Hunter Valley Operations South - Modification 5

Response to submissions

Prepared for HV Operations Pty Ltd | June 2017

Figure 3.2

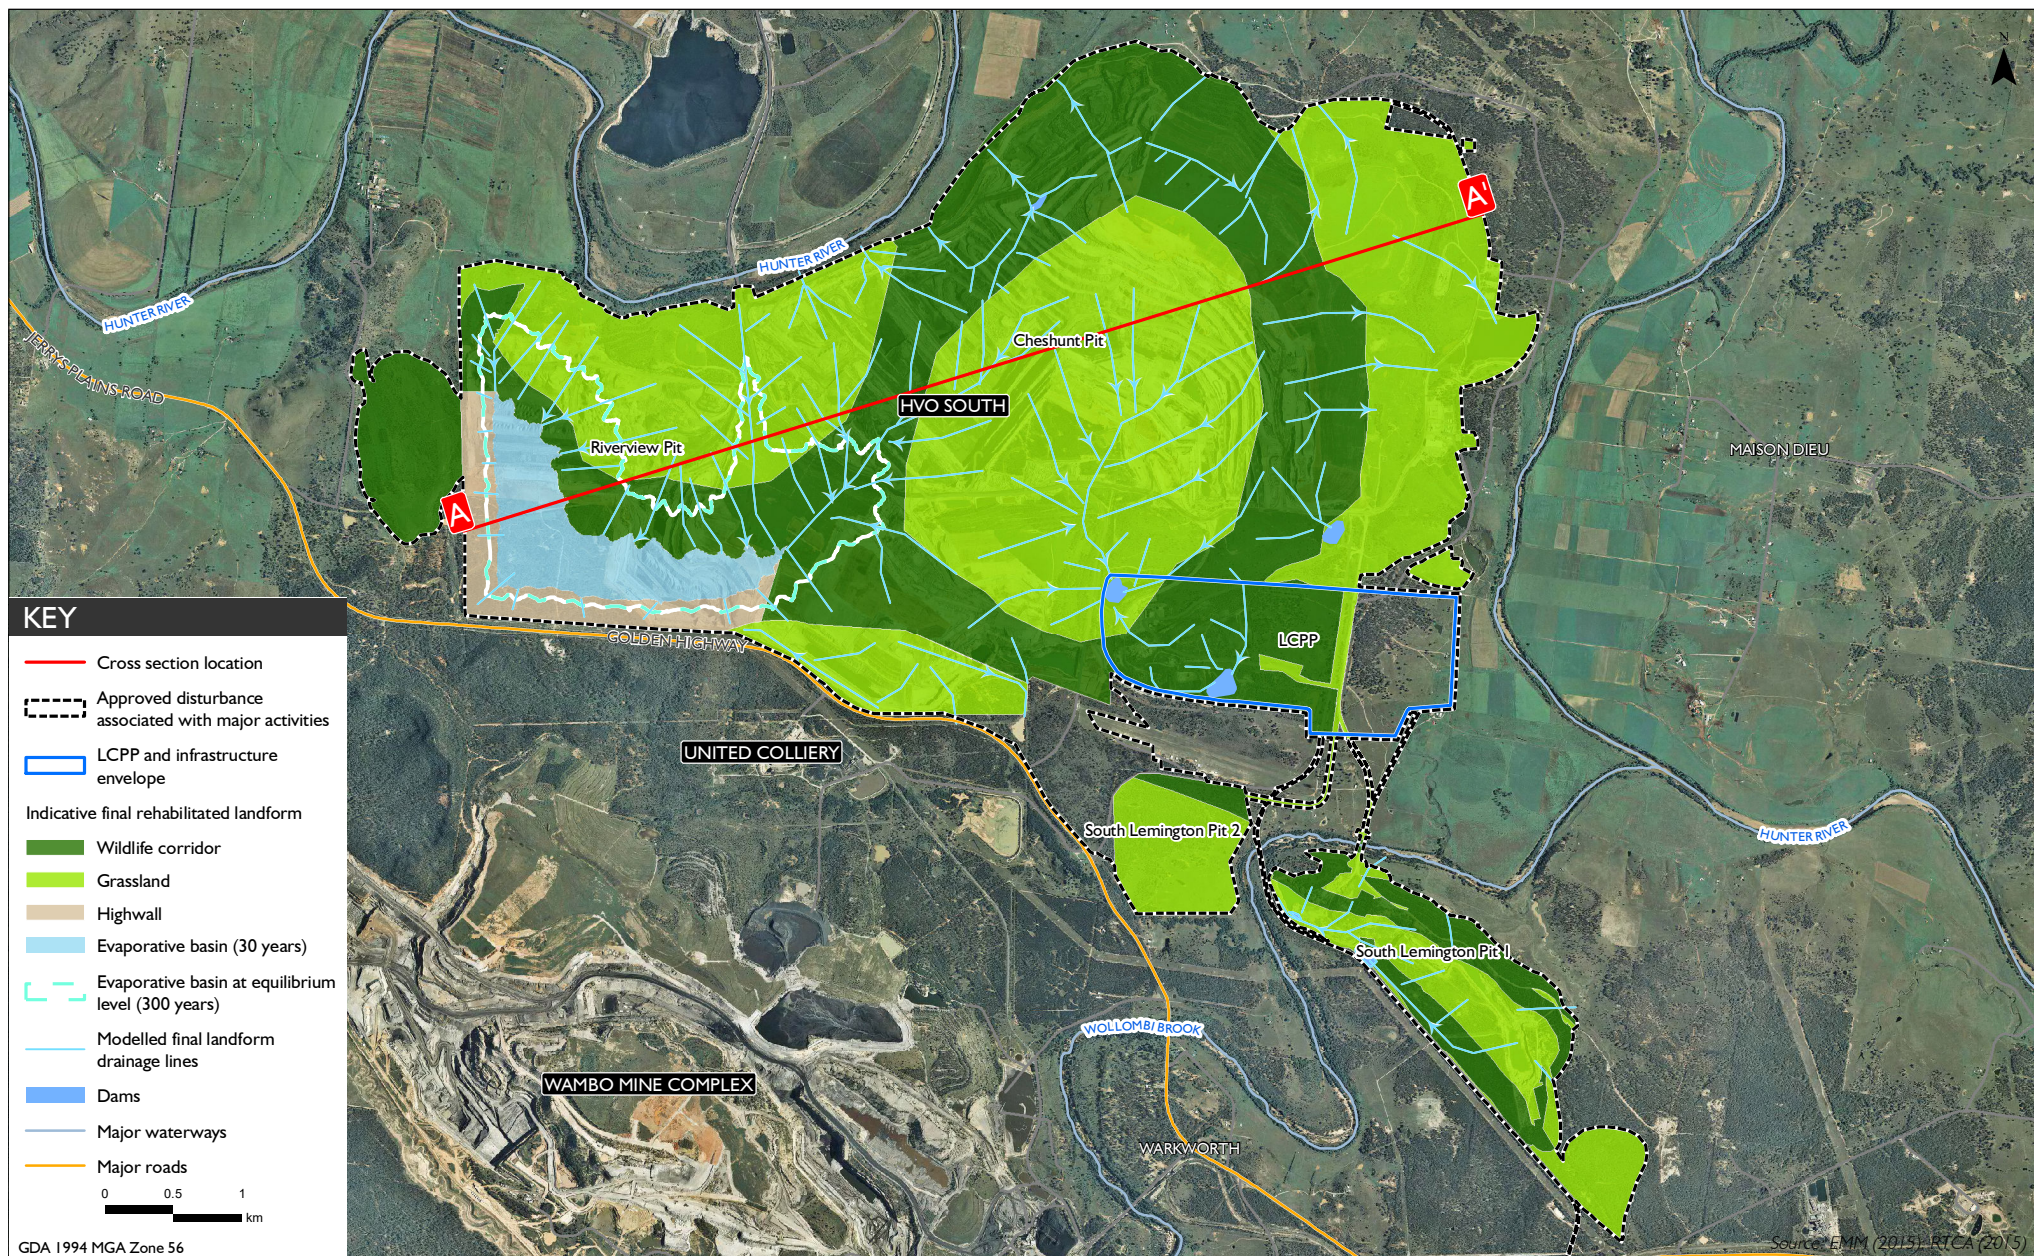
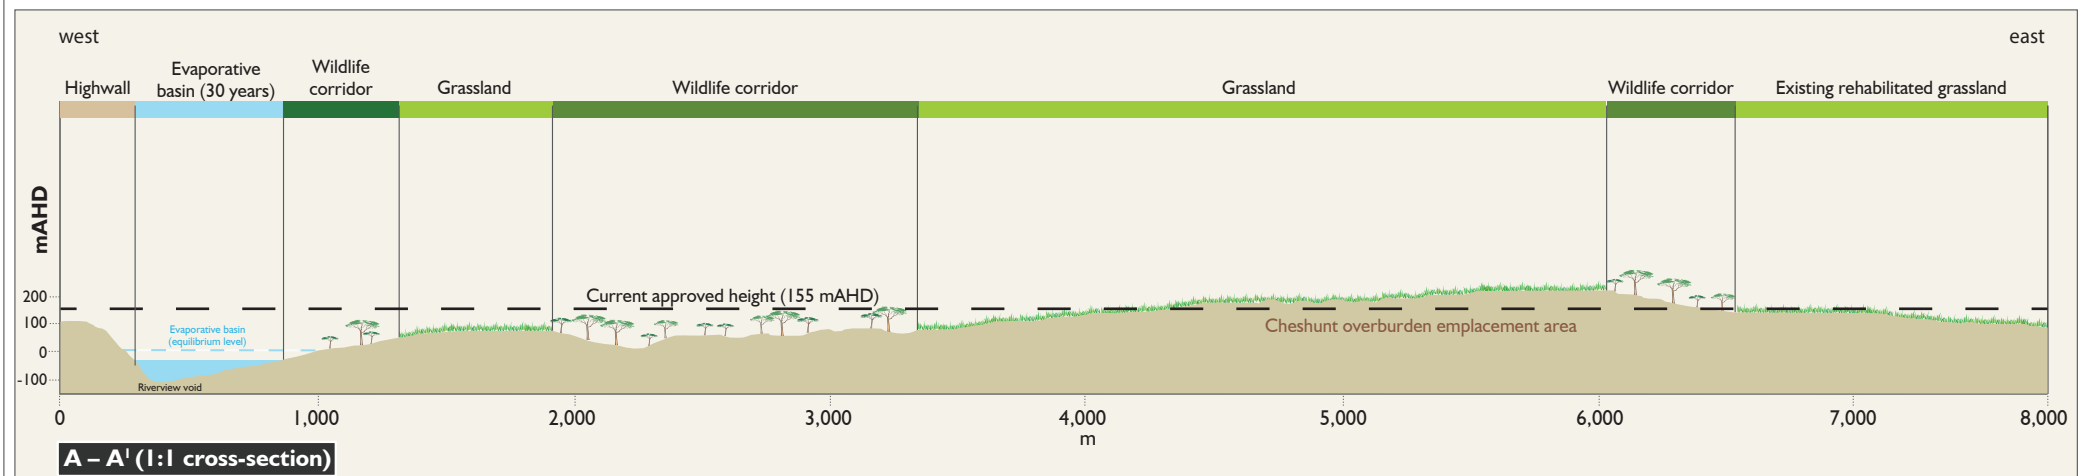
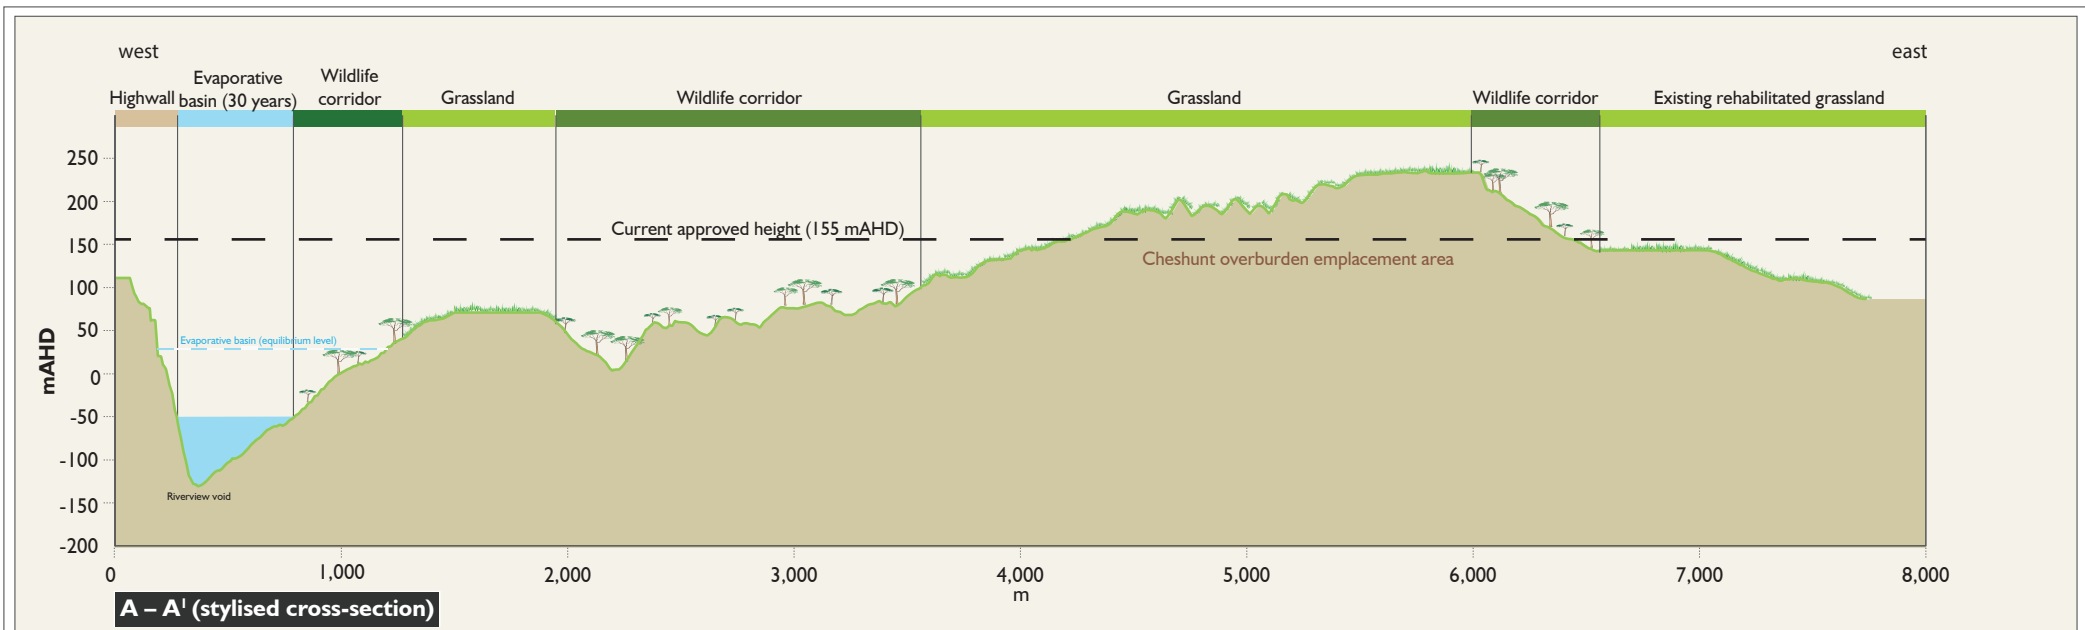
Figure 3.2 shows the proposed indicative final landform and provides a cross-section location which is shown in Figure 3.3. Figure 3.3 provides both the stylised cross-section (originally shown in the EA as Figure 13.2) and a 1:1 scaled cross-section to represent the proposed indicative final landform. The 1:1 scaled cross-section provides additional context to the micro-relief and final void slope angles. It demonstrates the low-wall and highwall slope angles as well as the height/depth in context to the overall disturbance footprint.

In summary, the slope angles of the highwall under the proposed modification are consistent with those of the currently approved mine plan. Importantly, the design of the final void prioritised a reduction in overall slope angle for the low-wall in order to increase the area of useable land available for sustainable agricultural practices (consistent with the requirements of the *Synoptic Plan – Integrated Landscapes for Coal Mine Rehabilitation for the Hunter Valley of NSW* (the Synoptic Plan) (Department of Mineral Resources 1999)) in the short, medium and long-term.

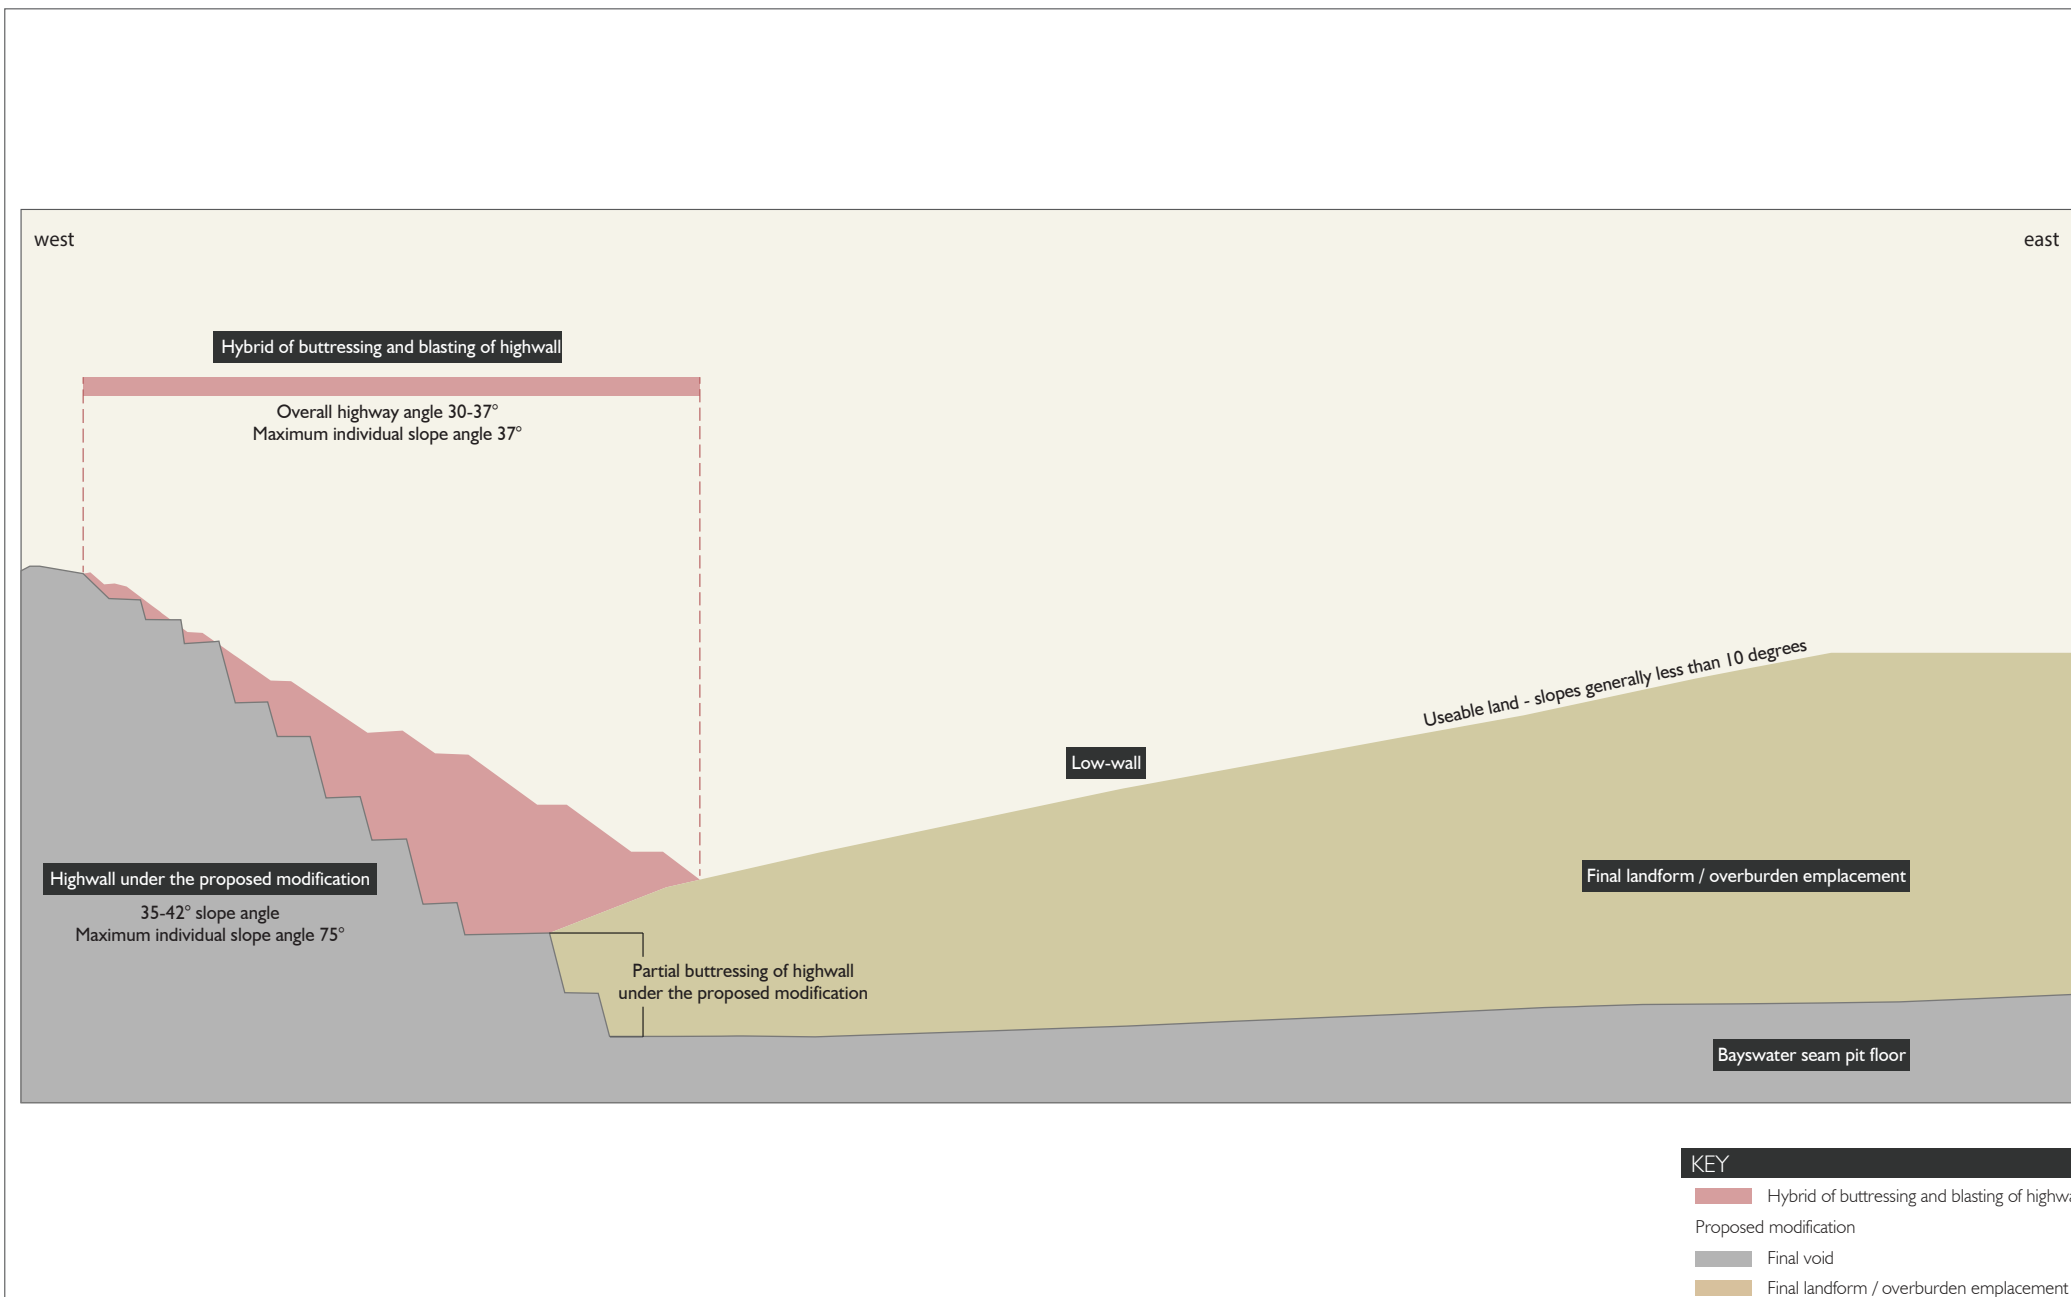
Figure 3.4 shows the highwall and final void under the proposed modification. This figure shows that the proposed modification already comprises a significant amount of buttressing above the pit floor and a number of safety benches on the exposed insitu highwall to achieve the desired overall 35 to 42 degree highwall slope angle, whilst also creating a gentler low-wall slope increasing the useable land available post-mining and reducing the surface catchment draining to the final void compared to the approved final landform.

It is considered that implementation of the available options to create a highwall of 37 degrees or less within the final void at Riverview Pit under the proposed modification is not viable due to the significant additional cost required to implement. Additionally, the increased noise, dust and visual amenity impacts on surrounding receptors and reduced final land use capability are inconsistent with the guiding design principles to avoid and minimise environmental impacts whilst maximising the areas available for post mining use.

Figure 4.2

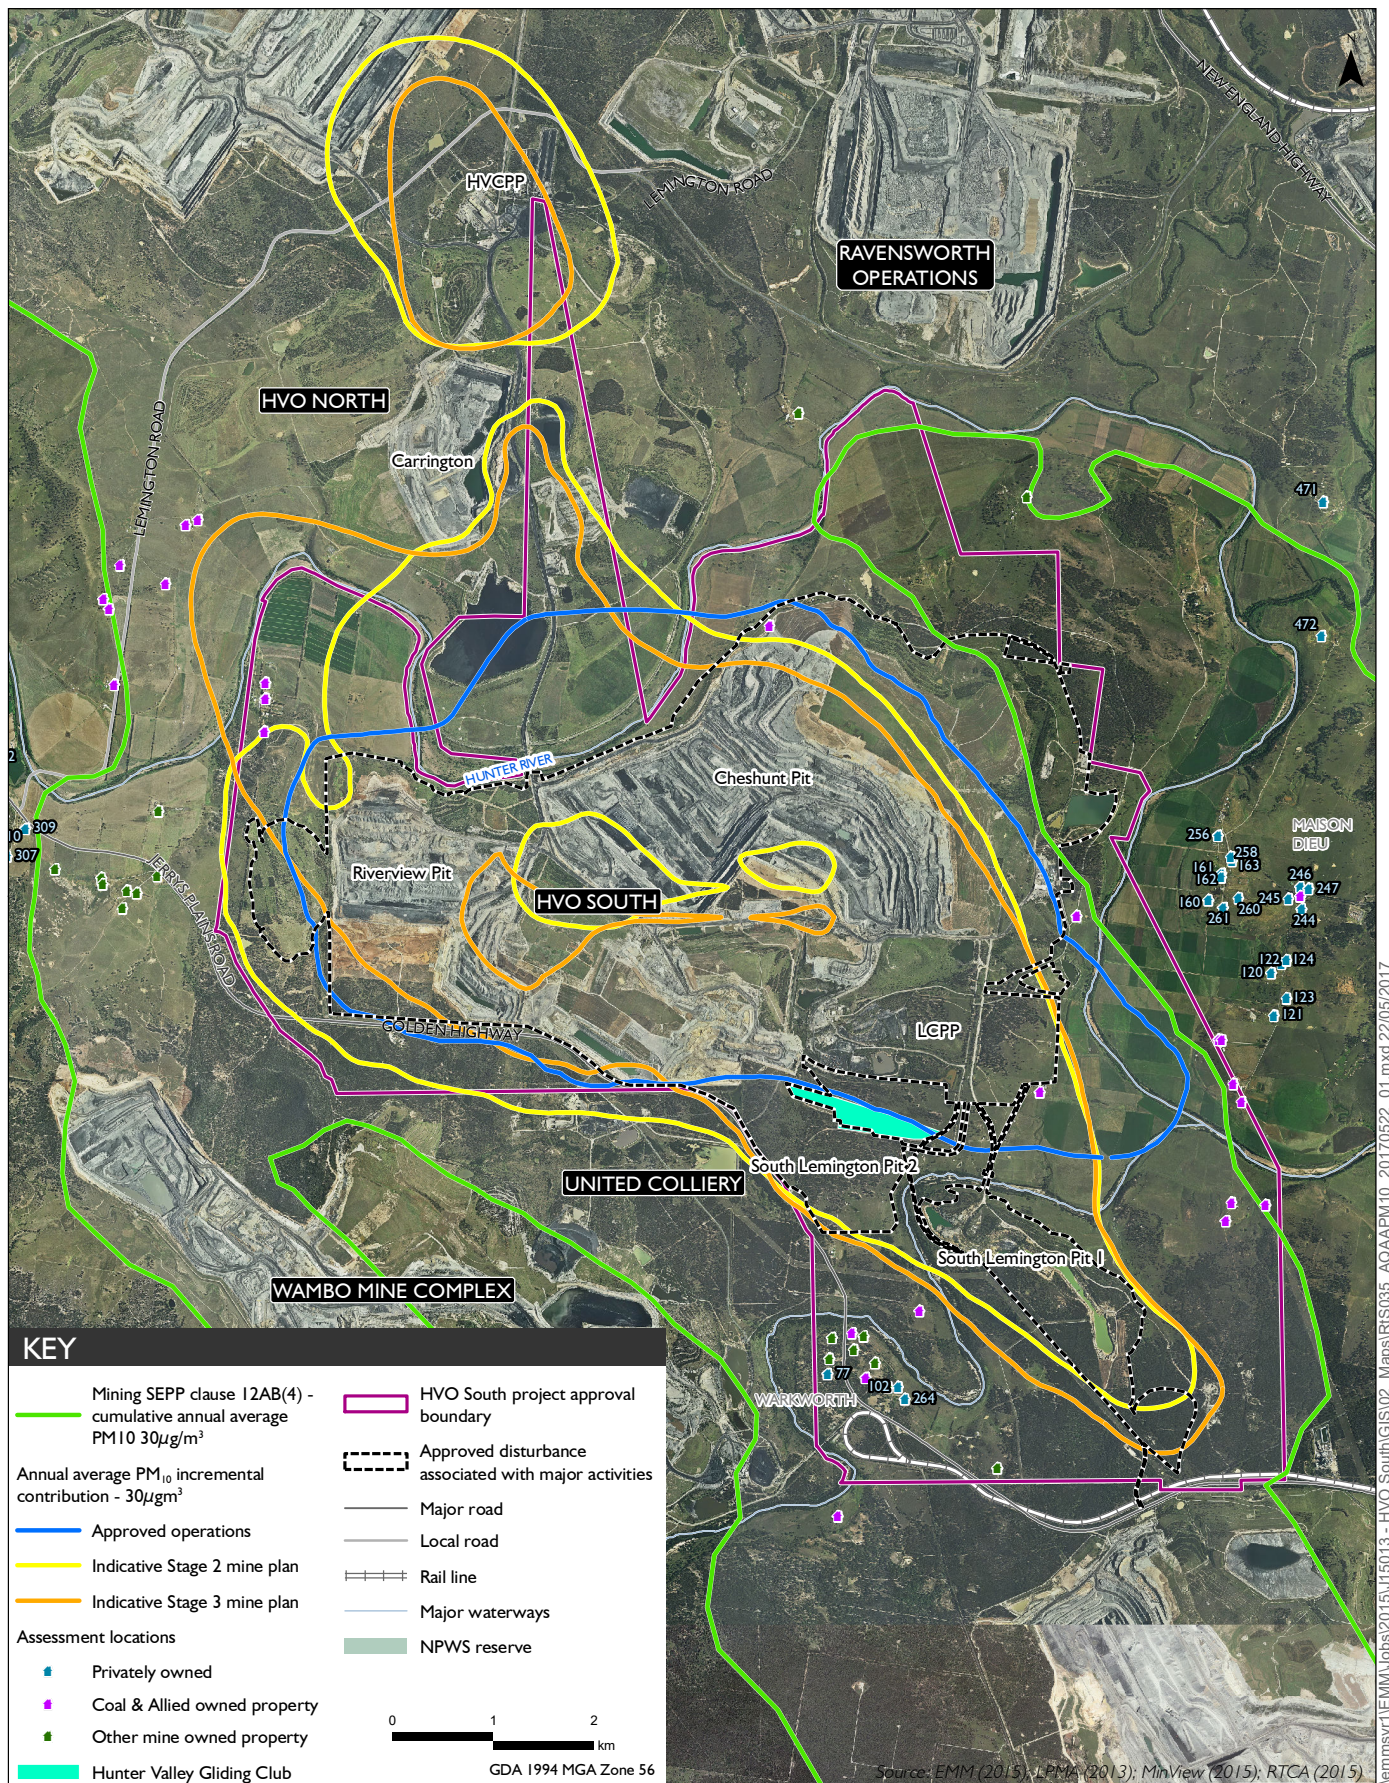
Coal & Allied recognises the Hunter Valley Gliding Club as a near neighbour. In response to its submission, we have updated the air quality modelling results in Figure 8.2 and Figure 8.3 of the EA to show the location of the Hunter Valley Gliding Club. These updated figures are included in Figures 4.2 and 4.3 of this RTS and have been provided to representatives of the Hunter Valley Gliding Club.
